LINCOLN CITY/LANCASTER COUNTY PLANNING STAFF REPORT

P.A.S.#: Preliminary Plat #01007
Carroll M5 Industrial Park

Date: July 11, 2001

Preliminary Plat #01007
N. 27th & Cleveland Ave.
Carrol M5 Industrial Park

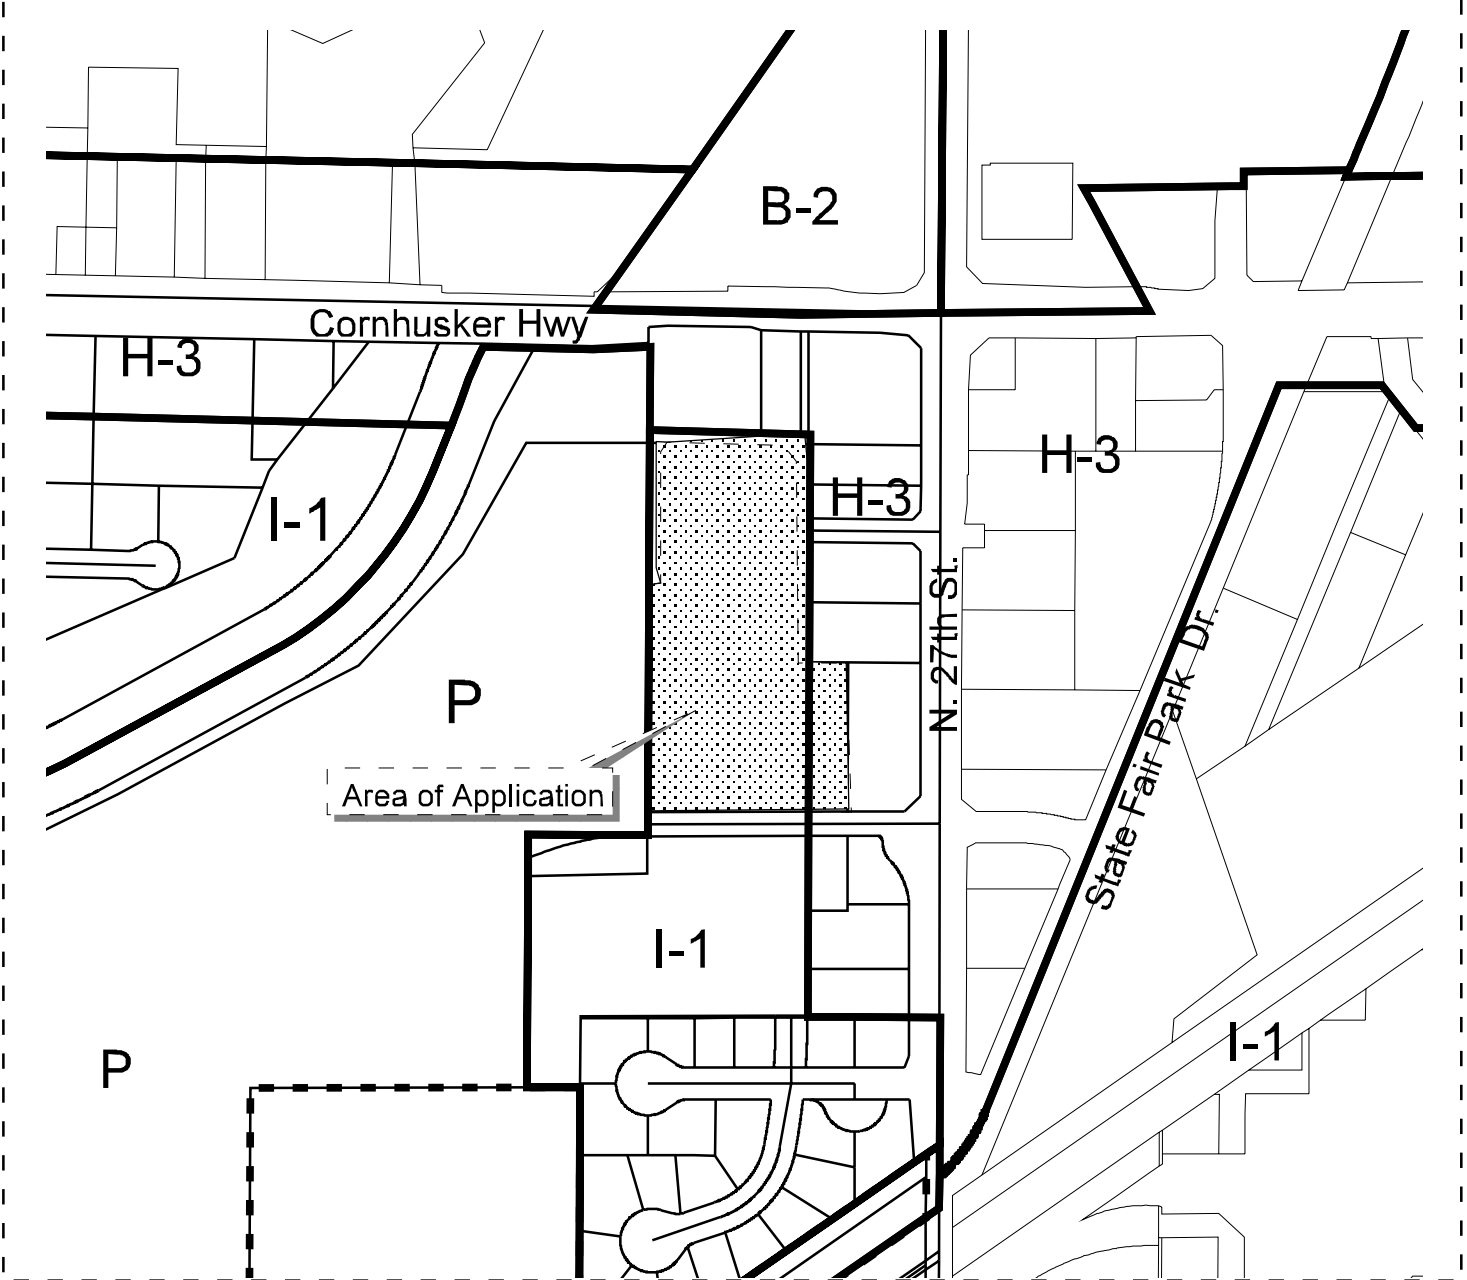
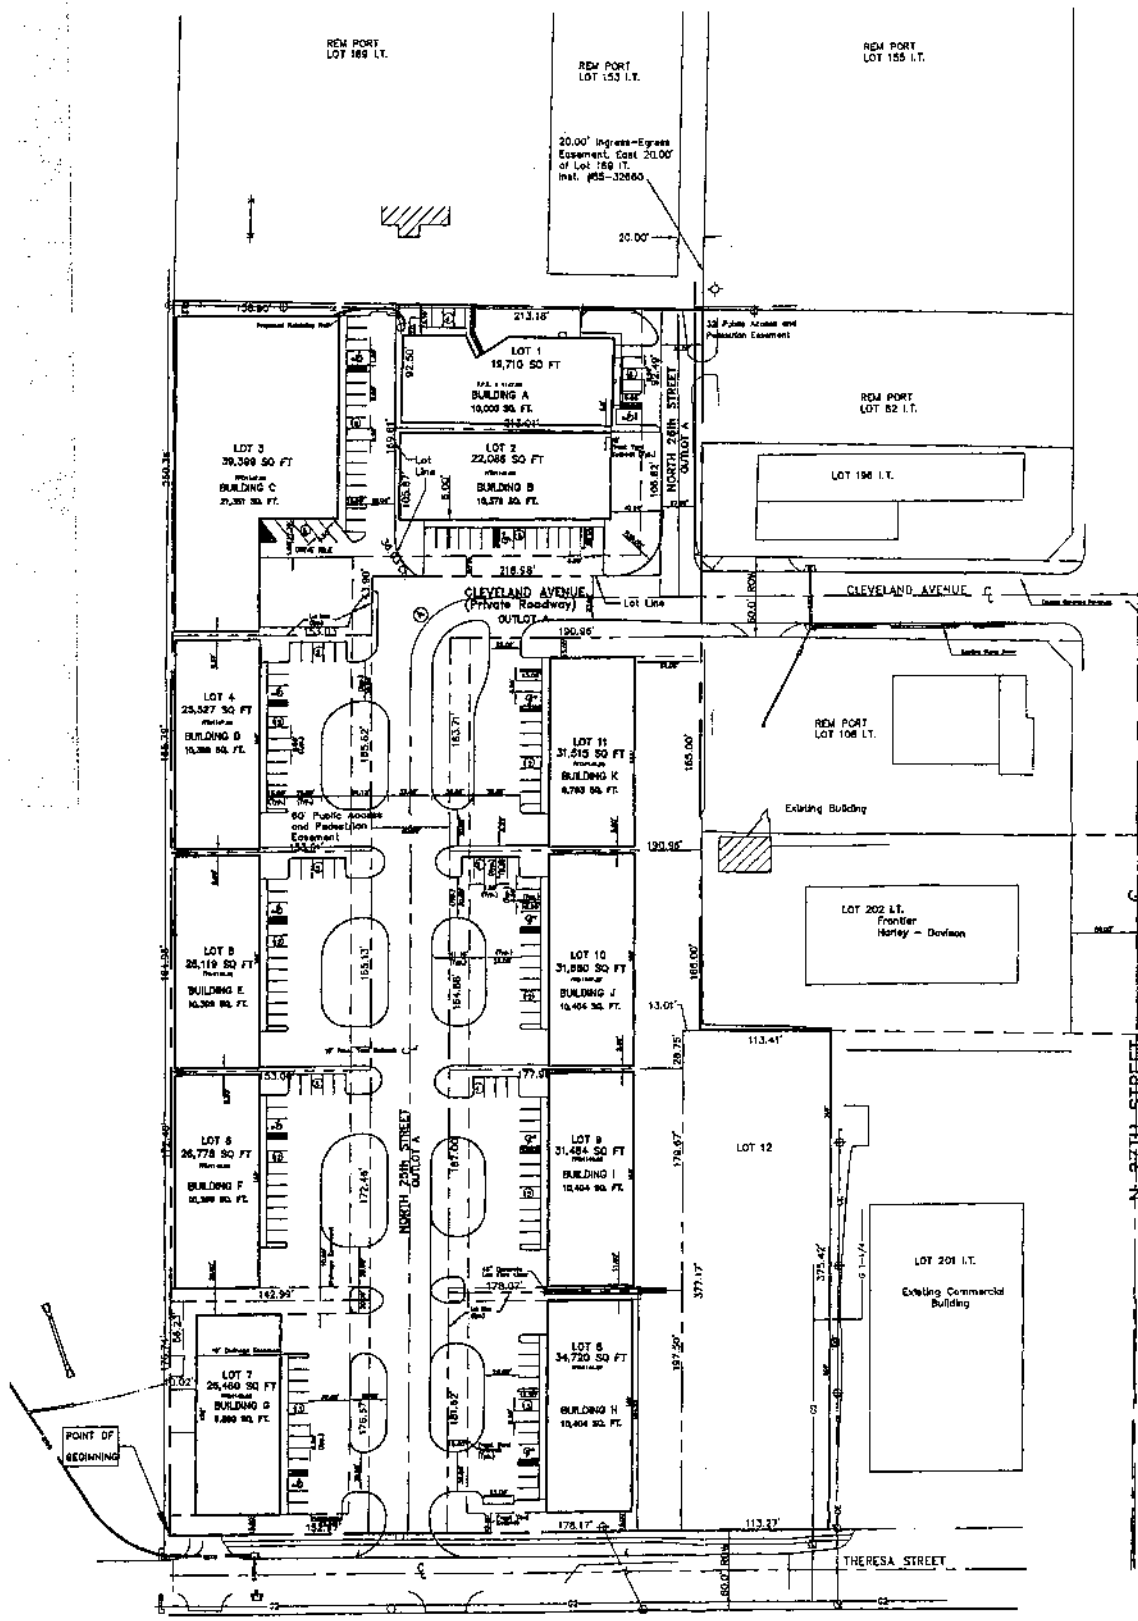
- 1.1.3 Sheet 5 should read "5 of 8," not "5 of 9."
 - 1.1.4 Remove Note 11 - it duplicates statements in Note 16.
 - 1.1.5 Sign the surveyor's certificate.

- 1.1.6 Remove building envelopes, building square footage, building dimensions, parking lot details, and parking lot dimensions.
 - 1.1.7 Remove the building and parking stall summary.

- 1.1.9 Add water lines and fire hydrants to the Utility Plan.
 - 1.1.10 Replace Honeylocust with a more flood tolerant species such as Patmore Ash or Swamp White Oak

- 1.1.11 Show sidewalks
 - 1.1.12 Increase curb radii as requested by Public Works and Utilities.
 - 1.1.13 Remove Note 15, which requested a waiver of sidewalks.
